Rev A: This bulletin replaces previous versions
March 18, 2014 Added 2800381 in part list.

COMPRESSOR DOOR HINGE PIN LOCK Prevost vehicles

On the vehicles affected by this bulletin, the compressor door adjustment will be secured by the addition of two screws on a tab under the hinge pin assembly.

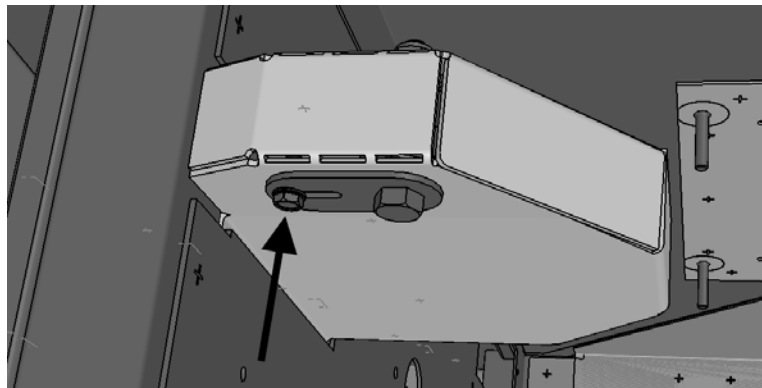
On the rear wall of the battery compartment, find the upper and lower hinge cover. Under the hinge cover add tab #2800381.

Secure the compressor door adjustment by adding a self-tapping screw #5001017. (Arrow)

If drilling is required, use a 0.166" drill (#19)
